MANASQUAN PLANNING BOARD MEETING AGENDA

Re: Boro File No. MSPB-R1871
Variance – Ocean Bay Developers LLC
Block 23, Lot 7.05
10 Branin Avenue
B-1 Business Zone
Borough of Manasquan, Monmouth County, NJ

Re: Boro File No. MSPB-R2130
Variance – Reilly
Block 71, Lot 112.03
75 Morris Avenue
R-2 Single-Family Residential Zone
Borough of Manasquan, Monmouth County, NJ

PLOT & GRADING PLAN

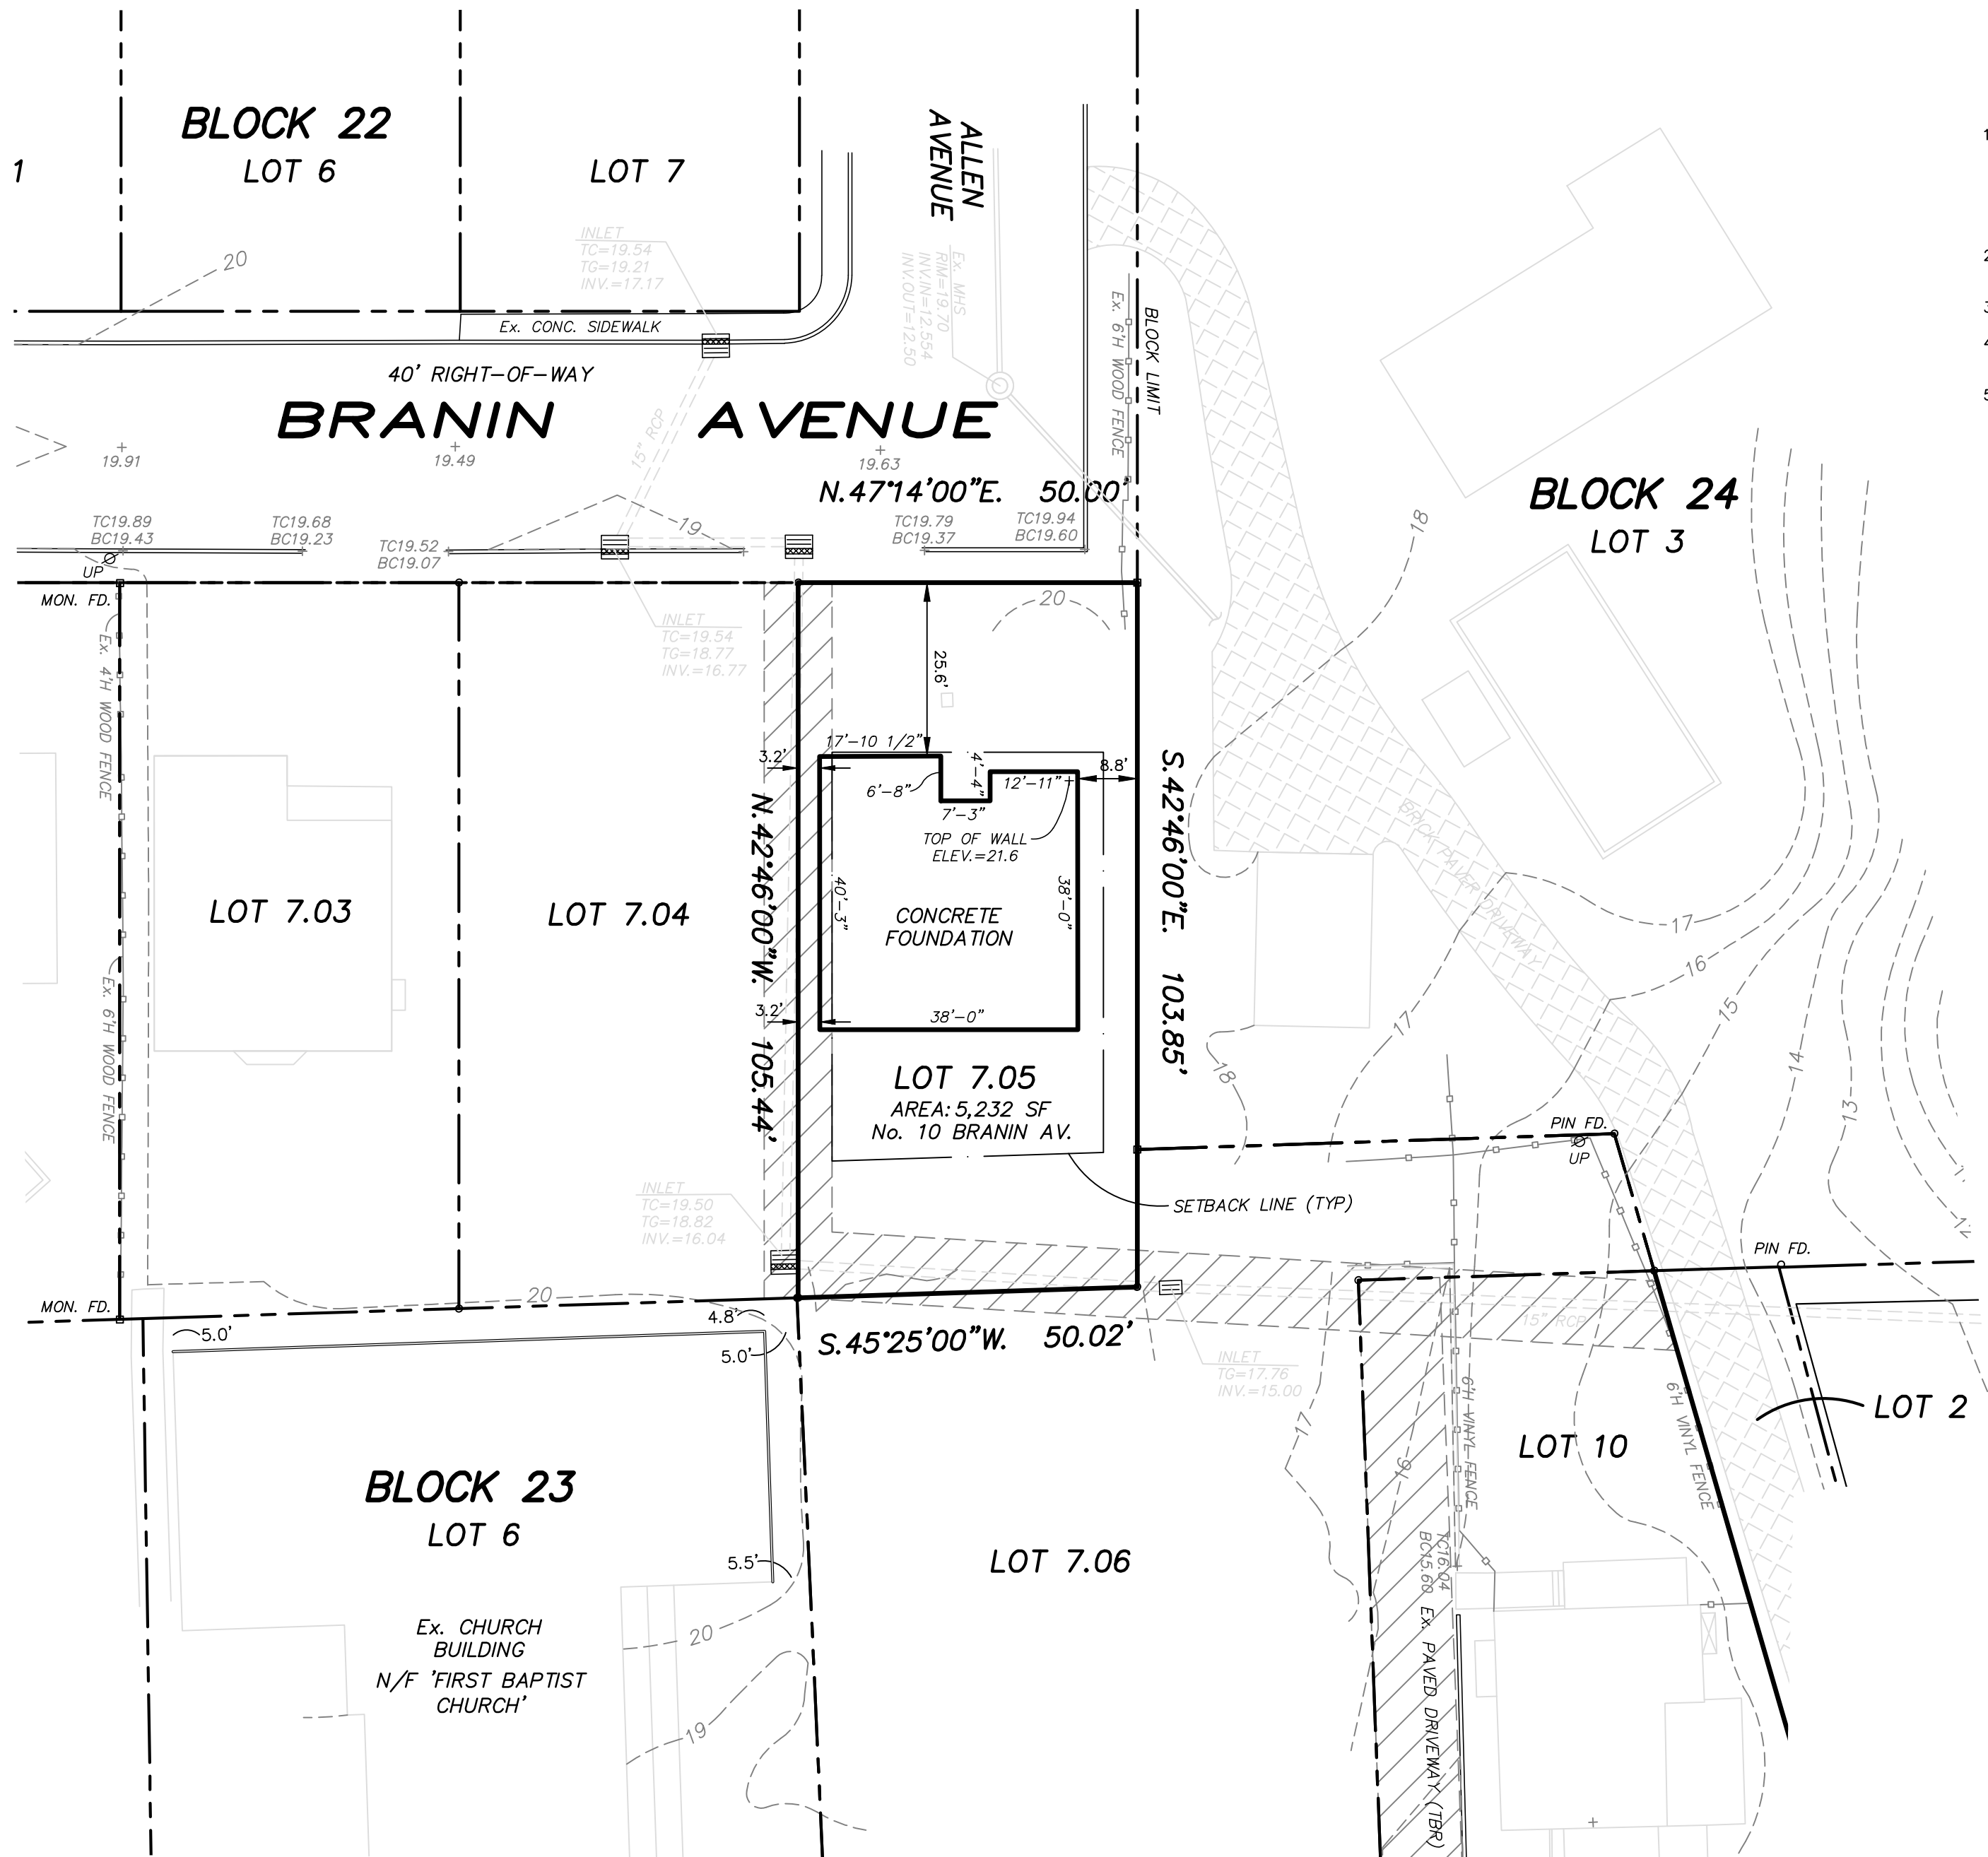
3. The requested variance occurs between the subject parcel and adjacent Lot 7.04 which the applicant also owns. It is suggested that the applicant consider potential deed restrictions, easements, or buffers as part of the variance request. However a ten foot wide drainage easement exists along the property line of the two properties which may impact any proposed restrictions.
4. A drainage recharge system was approved in the rear yard as part of the plot plan review for this application.
5. It appears that no trees will be removed as part of this application.
6. Any curb must be replaced along Branin Avenue as necessary.
7. All necessary building permits must be obtained prior to construction.

VARIANCE PLAN FOR
OCEAN BAY DEVELOPERS, LLC
 BLOCK 23 LOT 7.05
 TAX MAP SHEET No. 3
 MANASQUAN BOROUGH, MONMOUTH COUNTY, NEW JERSEY

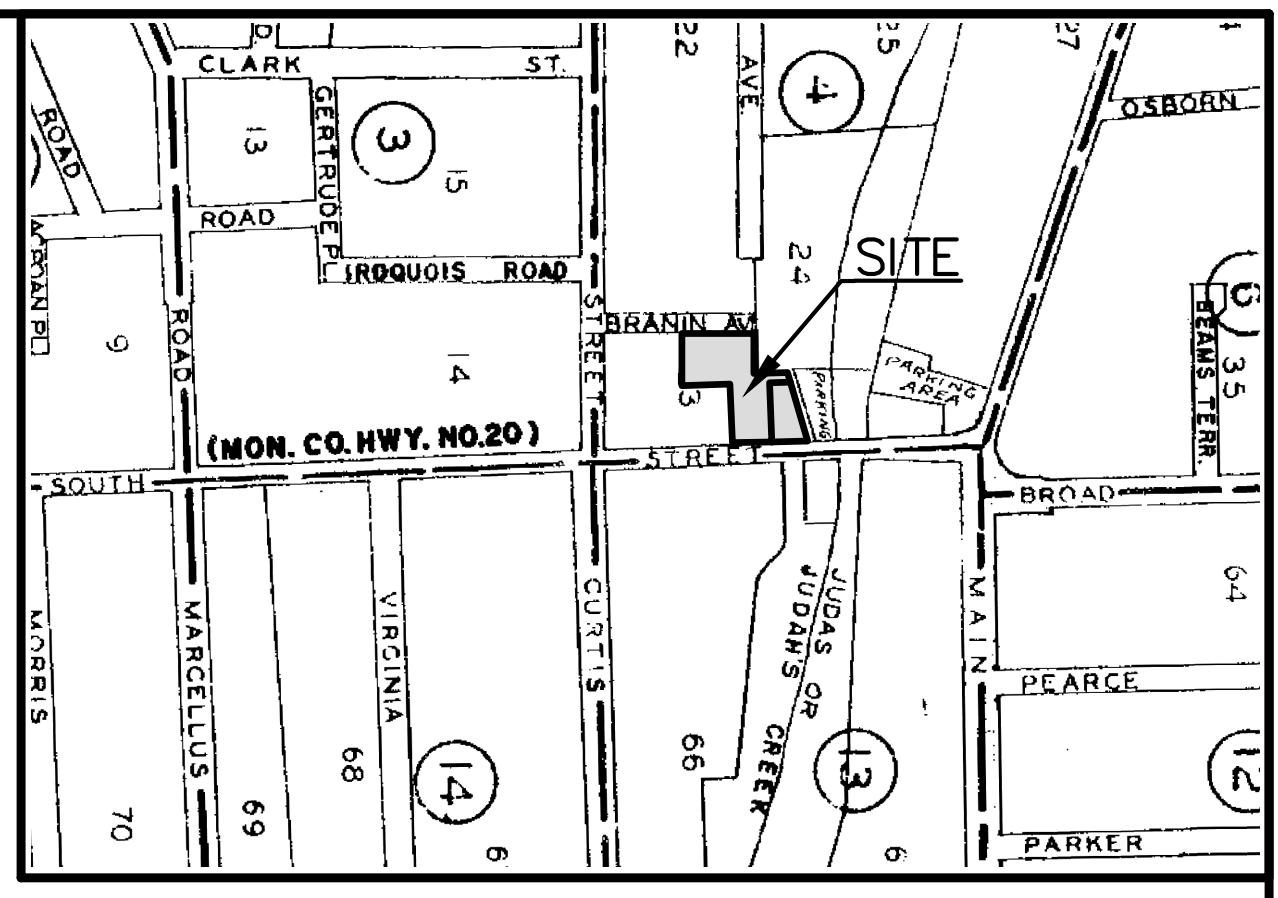
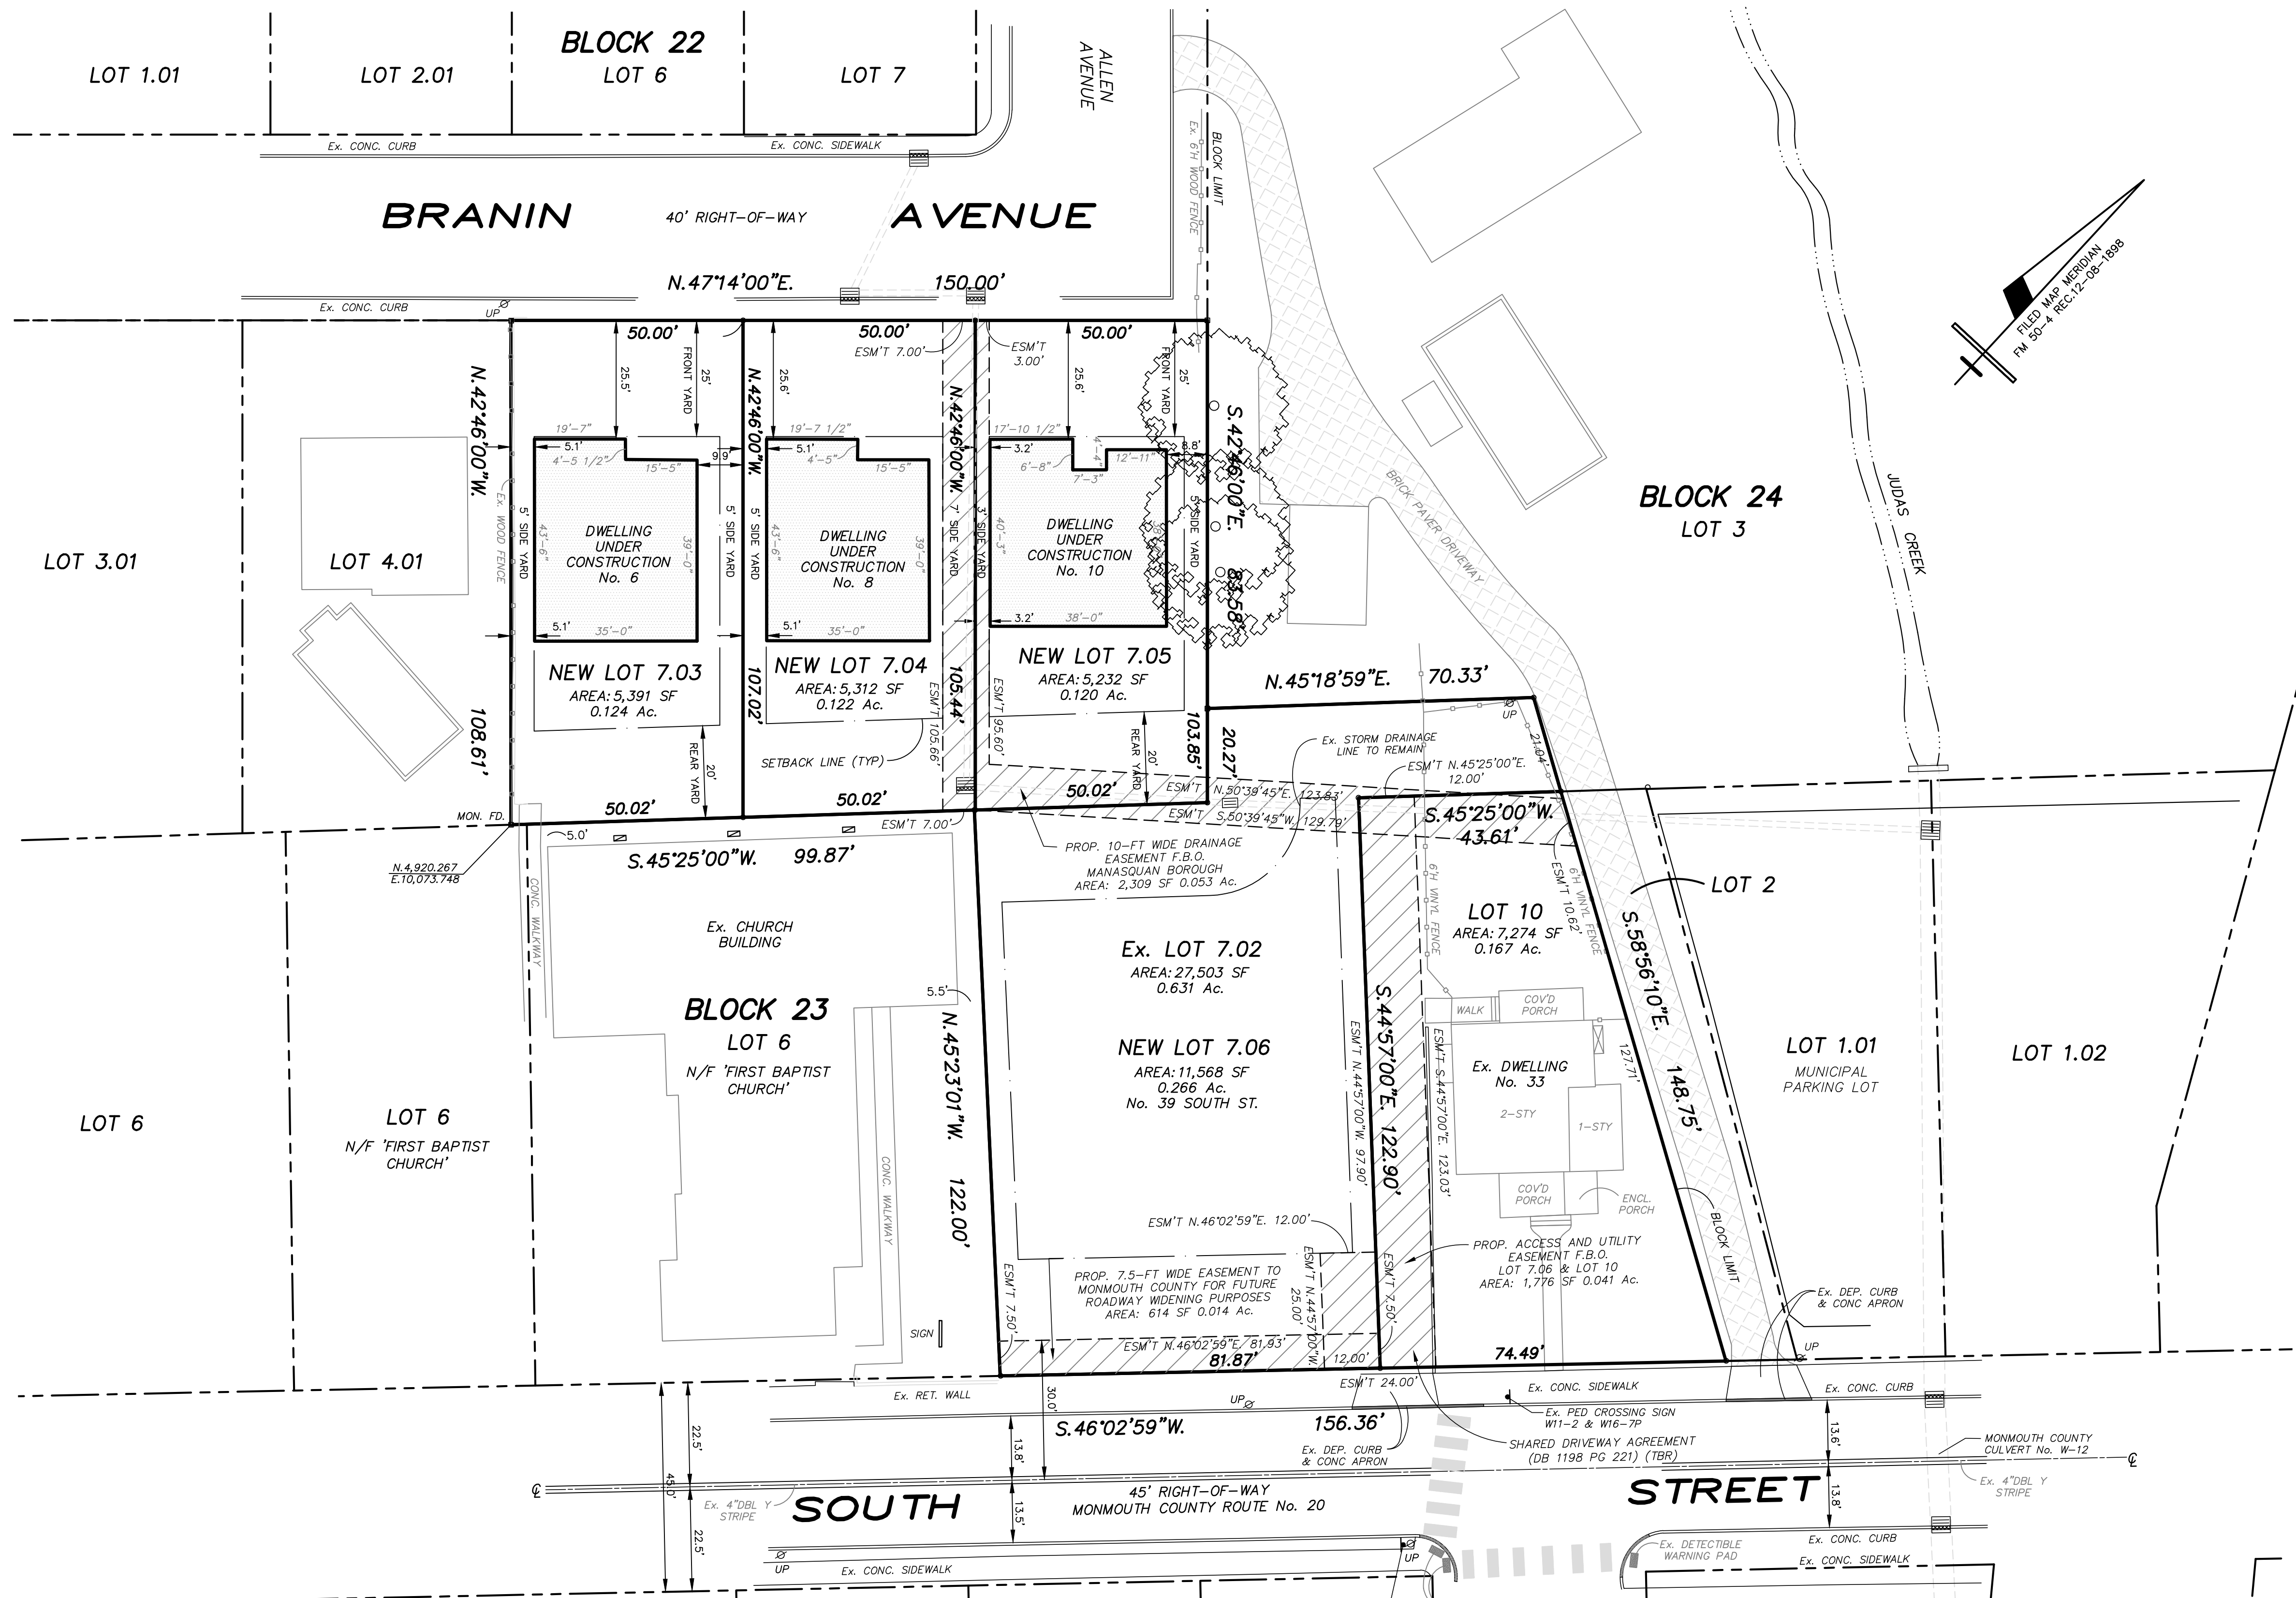
1. The property is located in the B-1 Single Family Residential Zone. The existing and proposed residential use is permitted by the previous Board approvals.
2. The following bulk ('c') variance is required as part of this application:
 - a. A minimum side yard setback of 5 feet is required, whereas a setback of 3.2 feet is proposed on the southwest side.

PROPOSED PLOT PLAN
(1"=20')

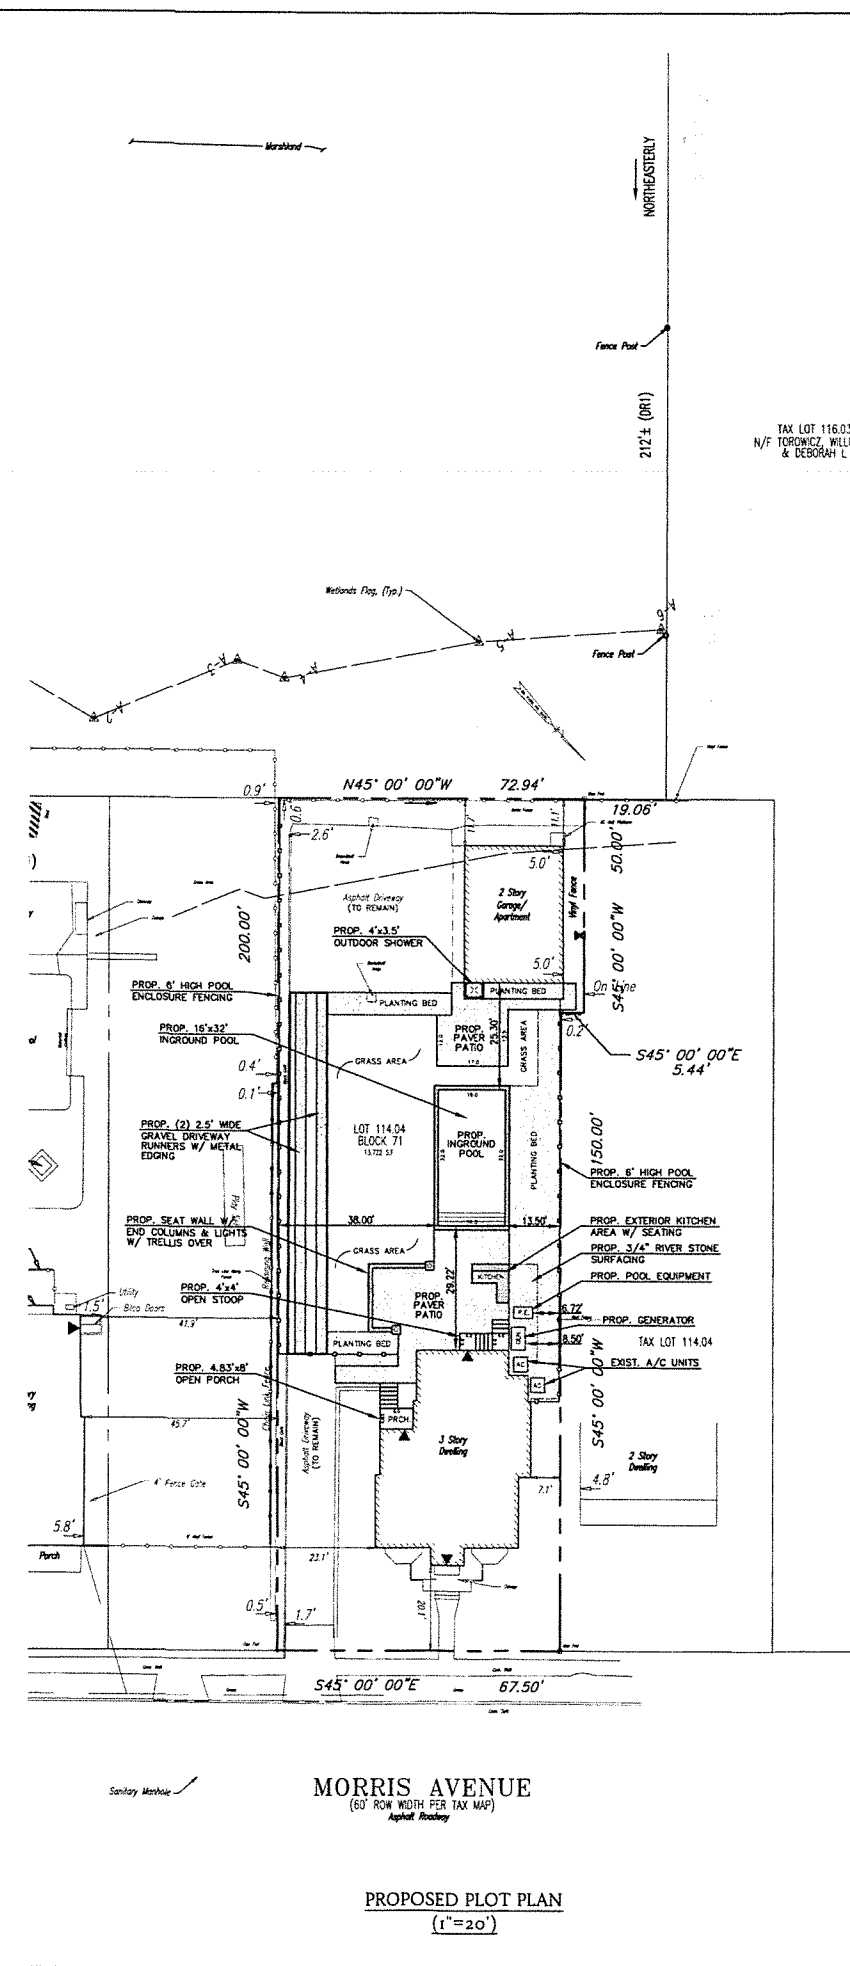
1. The property is located in the R-2 Single Family Residential Zone.
2. The following use ('d') variance is required as part of this application:
 - a. Only one single family residential dwelling per lot is permitted, whereas two detached residential dwelling units exist and are proposed.
3. The following non-conformities exist on Lot 112.03 and are not proposed to be modified as part of this application:
 - a. A minimum side yard setback of 5 feet is required, whereas a setback of approximately 4 feet exists and is proposed to the air conditioning unit (west).
 - b. A minimum front yard setback of 25 feet is required, whereas a setback of 20.1 feet exists and is proposed to the front dwelling.

4. The base flood elevation for the property is 10 (Zone AE).
5. A drainage recharge system in accordance with the Borough's stormwater ordinance is not required as the proposed improvements will not increase the impervious coverage on the lot.

6. The proposed grading of the lot does not appear that it will alter the existing drainage patterns, however the applicant's engineer should confirm this and indicate that there will be no negative effects to neighboring properties. The proposed grading should also consider the sitting wall which could block surface runoff from draining off the patio area.

7. Pool filter backwash discharge and any other pool discharge shall be directed so as to not negatively impact adjacent properties.
8. It does not appear that any existing trees will be removed as part of the application.
